MIL "ON" DTC P2610

YEAR(S)	MODEL(S)	ADDITIONAL INFORMATION
2014 - 2016	Sequoia

Some 2014 – 2016 Sequoia vehicles may exhibit a MIL "ON" condition with Diagnostic Trouble Code (DTC) P2610, indicating an ECM/PCM Engine Off Timer Performance condition. The Engine Control Module (ECM) logic has been modified to reduce the possibility of this condition. Follow the Repair Procedure below to address this condition.

Figure 1. Location of Authorized Modification Label for 2014 – 2016 Sequoia

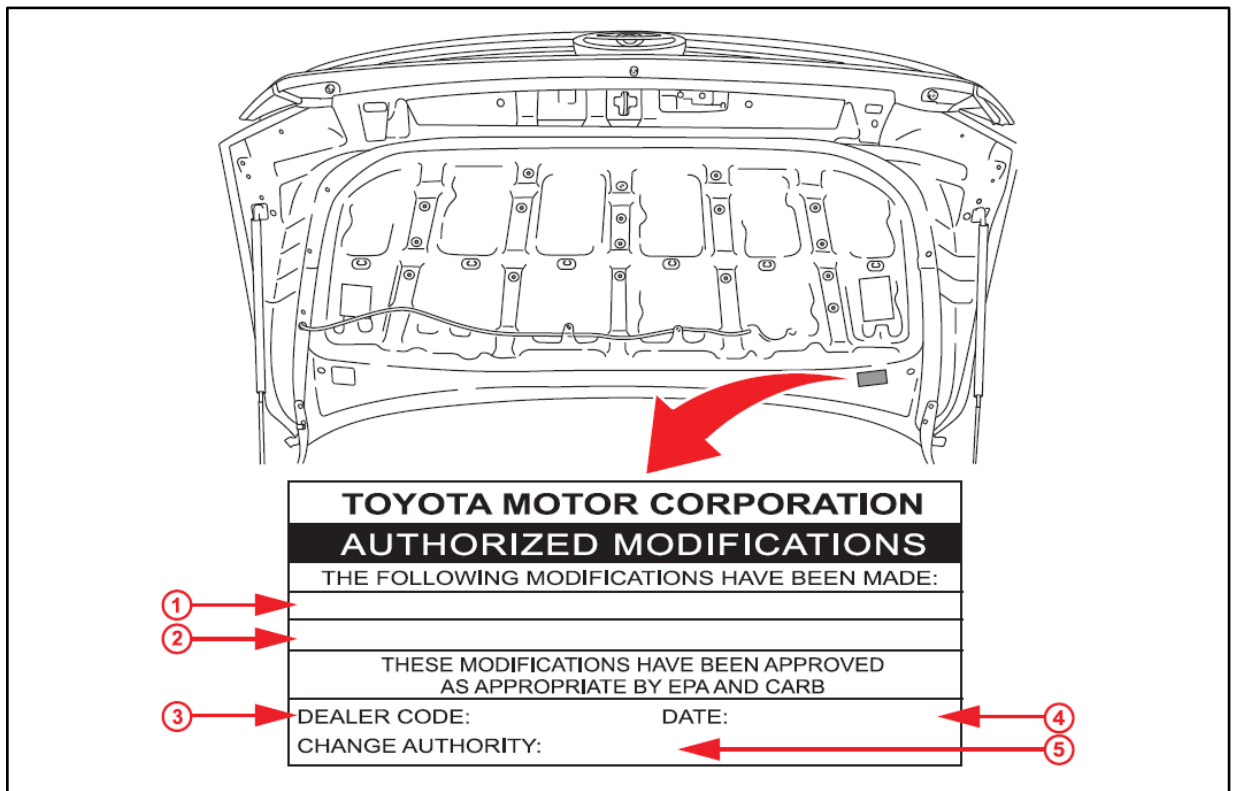
2. Check for the Authorized Modifications Label affixed to the vehicles in the location shown below. Confirm if the ECM (PCM) calibration has been updated.

- Install the Authorized Modifications Label.
 - Using a permanent marker, enter the following information on the label:
 - ECM part number [*Refer to the **Parts Information** section for the **NEW PART NUMBER***]
 - Calibration ID(s) [*Refer to the **Calibration Information** section for the **NEW CALIBRATION ID***]
 - Dealer Code
 - Repair Date
 - Change Authority [**This bulletin number**]
- Affix the Authorized Modifications Label to the vehicle at the location shown in Figure 1. The Authorized Modifications Label is available through the MDC, P/N 00451-00001-LBL.
- Test drive vehicle to confirm proper vehicle operation.
